ENGINEERING REPORT

SUBJECT ENGINE PRELUBE/KEEPWARM SYSTEM REQUIREMENTS

REPORT
TITLE KEEPWARD L.O. SYSTEM MODIFICATION
NUCLEAR STANDBY UNITS (OP ENGINES)FILE VTS-985-082881-01R
NUMBER

DATE AUGUST 28, 1981

FIGURE 3 - ENGINE INTERNAL MODIFICATIONS

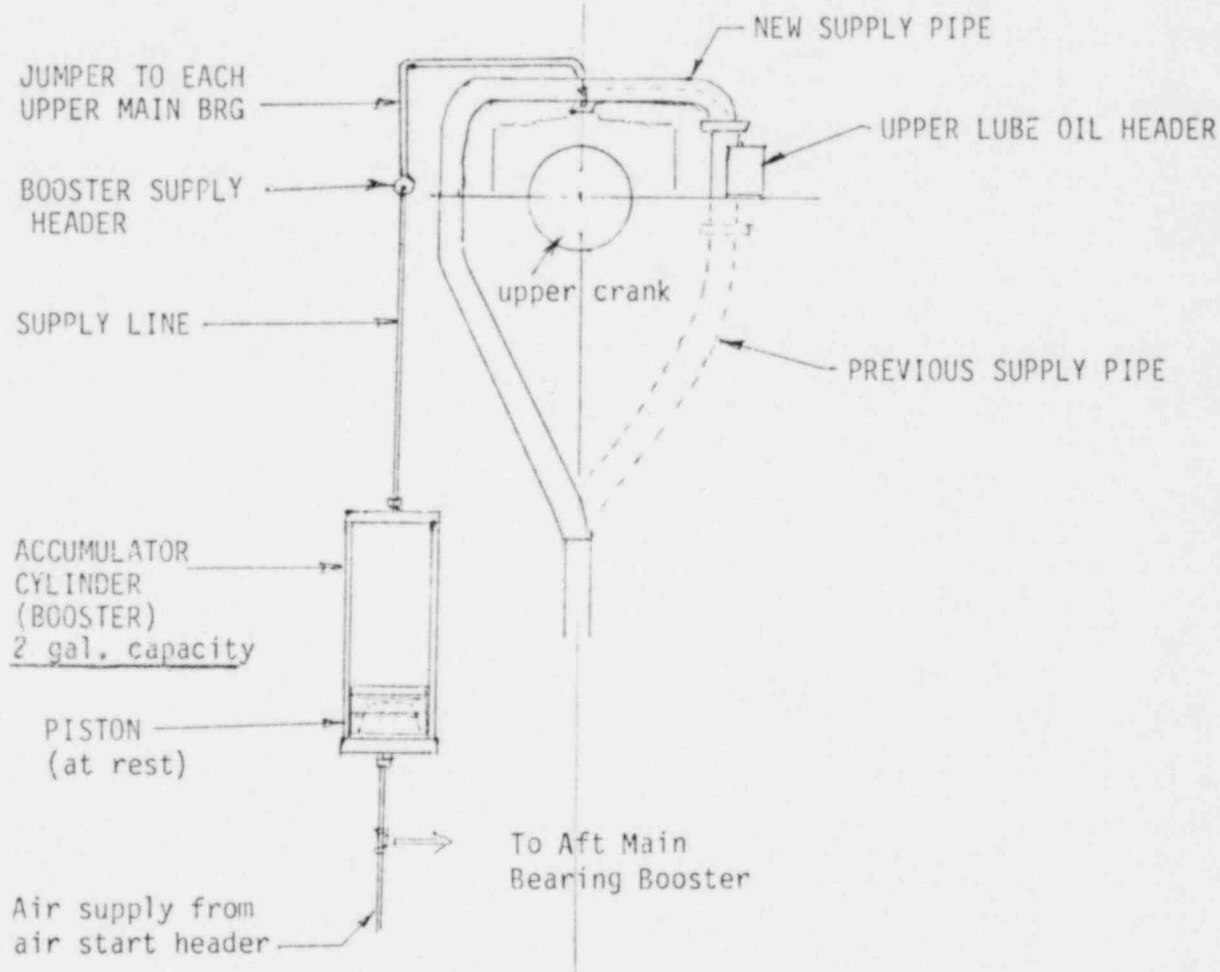
MODIFICATION TO INTERIOR OF ENGINE (Ref: Figure 3)

This modification consists of rerouting the supply to the upper L.O. header such that the header will not readily drain (a loop of tubing up over the crankshaft above the level of the header). See Figure 3.

This modification also consists of adding a lube oil booster/accumulator system to the upper crankline, similar to that used on the aft lower main bearing. This booster system fills with oil during normal engine operation. The next time the engine is started, the lube oil accumulated in the cylinder assembly is forced by starting air pressure acting on the opposite side of a piston, to be fed into the bearings along the upper crankline, thus filling the bearings with oil as the engine begins to be rotated in starting.

No external connections are required with this system as the air supply to the accumulator is tied internally to that of the aft main bearing booster system. The system is self regulating.

Parts for this system are identified on drawings and B/M #16403478 (Release PC3752).
